JUNCTION CITY PLANNING FINDINGS FOR A TYPE-I DEVELOPMENT REVIEW

File Number: DEV-21-08, 287 W 5th Avenue

Summary: Development Review conditional approval granted to allow conversion of a single-family dwelling to a tri-plex in the Central Commercial (C2) zone.

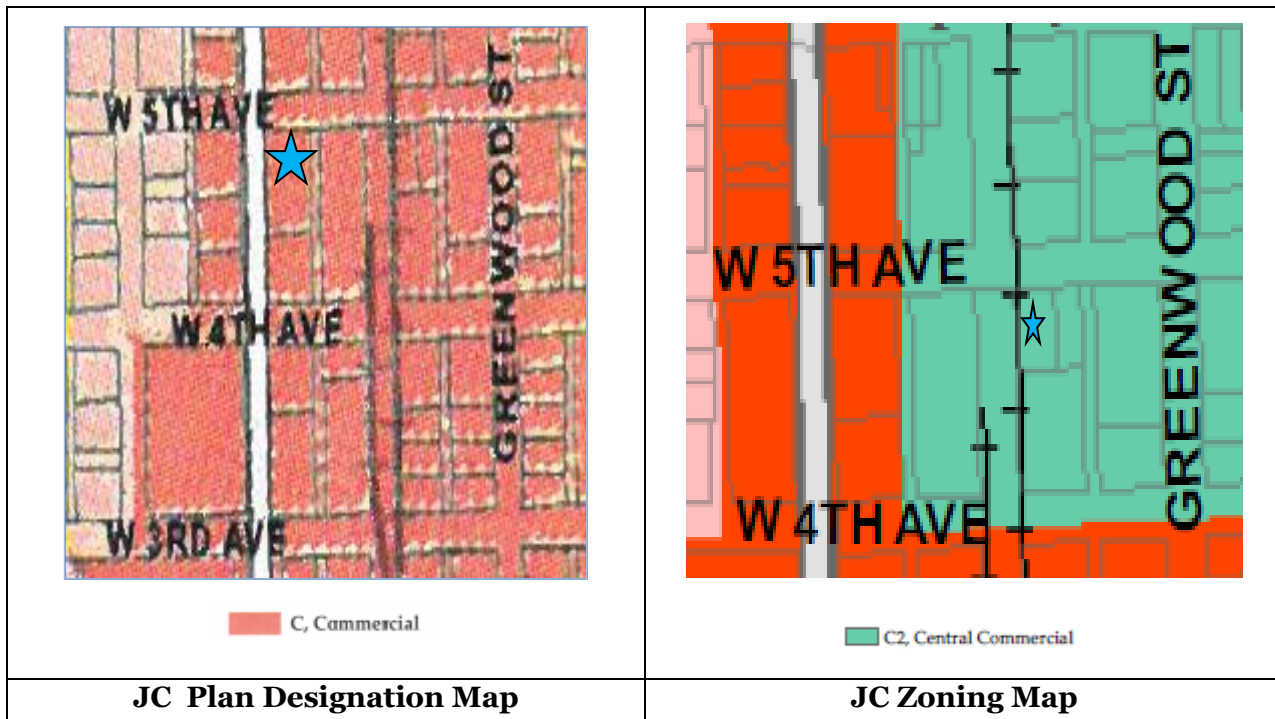
Referral comments on the application were requested from various affected service providers and City departments on July 30, 2021. On September 2, 2021, the applicant submitted a re-designed site plan. The exterior staircase was moved to the east side of the exiting structure from the west, the building envelope was expanded 1'-8", and the parking area rearranged. The referral was sent a second time to all city departments and outside affected agencies on September 28, 2021, with the revised site plan.

Finding: As shown on the revised site plan submitted September 2, 2021, the new staircase will be on the exterior of the building. The staircase is not proposed to be recessed, nor incorporated into the building architecture. As stated in the criteria, stairways that are simply hung from the building exterior are prohibited. Thus, the following condition is warranted.

Finding: Off-street parking is addressed under JCMC 17.90.010 later in this report. There are no streets contained within the subject site. As shown in the applicant's revised site plan submitted September 2, 2021, the parking is located at the rear of the building. Pedestrian walkways connecting building entrances and parking are not shown on the submitted site plan. The revised site plan indicates some landscaping; however, a landscape plan was not submitted as part of the application materials. Thus, the following condition is warranted.

Finding: The revised site plan submitted September 2, 2021, does not include trash receptacle location or screening. Public Works commented the garbage trucks would not be able to access the parking lot and would require each dwelling unit to have a wheeled tote for garbage and another for recycling. The residents will be responsible for wheeling the totes to the curb on Holly Street on garbage day. Thus, the following conditions is warranted.

Finding: Proposed and existing walkways from the public sidewalk to the building are shown on the site plan submitted on September 2, 2021. However, no walkways are shown from the parking area to the building entrances. Thus, the following condition is warranted.

Finding: The proposed landscaping shown on the revised site plan submitted September 2, 2021, does not comply with the standards listed above. Therefore, the following condition is warranted.

Finding: The submitted plans show parking for five vehicles, and the location of the existing access point. The subject site is on the southeast corner of Holly Street and West 5th Avenue. The existing access point is on Holly Street. The property to the south is vacant. The site has existing sidewalks, curbs, and gutters. The roadway is marked. The revised site plan submitted on September 2, 2021, does not include internal pedestrian circulation. Thus, the following condition is warranted.

site plan submitted September 2, 2021, does not include pedestrian walkways connecting the parking area to building entrances. Thus, the following condition is warranted.

Finding: The applicant proposes to convert a single-family home to multi-family with three dwelling units. A minimum of three bicycle parking spaces must be provided. The revised site plan submitted on September 2, 2021, indicates there will be bicycle parking under the exterior staircase on the east side of the building. However, the site plan does not state the number of bicycle parking spaces to be provided or their dimensions. Thus, the following condition is warranted.

Finding: As noted earlier in this report, a total of five parking spaces are required for this proposal. Landscaping is proposed on the revised site plan submitted September 2, 2021; however, a landscape and irrigation plan was not submitted as part of this proposal. Therefore, the following condition is warranted.

Finding: As shown in the revised site plan submitted September 2, 2021, there is a ramp from the existing Holly Street sidewalk to the entrance for units A and B. The site plan does not indicate the walkways will meet handicapped accessible (ADA) design standards, as required by State and Federal laws. Thus, the following condition is warranted.

CONDITION: Prior to issuance of a building permit, the applicant shall submit plans demonstrating compliance with JCMC 17.20.140(E).

CONDITION: At the time of building permit submittal, the applicant shall submit a site plan with the trash receptacle(s) screening in compliance with JCMC 17.20.140(F).

CONDITION: At the time of building permit submittal, the applicant will submit a site plan in compliance with JCMC 17.20.140(H).

CONDITION: Prior to issuance of a building permit, the applicant shall submit a landscape and irrigation plan in compliance with JCMC 17.20.140(I).

CONDITION: Prior to issuance of a building permit, the applicant shall submit a site plan with pedestrian circulation in compliance with JCMC 17.85.110(A).

CONDITION: Prior to issuance of a building permit, the applicant shall submit a site plan with internal pedestrian circulation in compliance with JCMC 17.85.110(B).

CONDITION: Prior to issuance of a building permit, the applicant will submit a site plan with a minimum of three covered bicycle parking spaces, each measuring six feet in length, and two feet in width with seven feet of vertical clearance.

CONDITION: Prior to issuance of a building permit, the applicant shall submit a landscape and irrigation plan in compliance with JCMC 17.90.030(H)(9).

CONDITION: Prior to issuance of a building permit, the applicant will submit a site plan which demonstrates compliance with state and federal ADA standards.
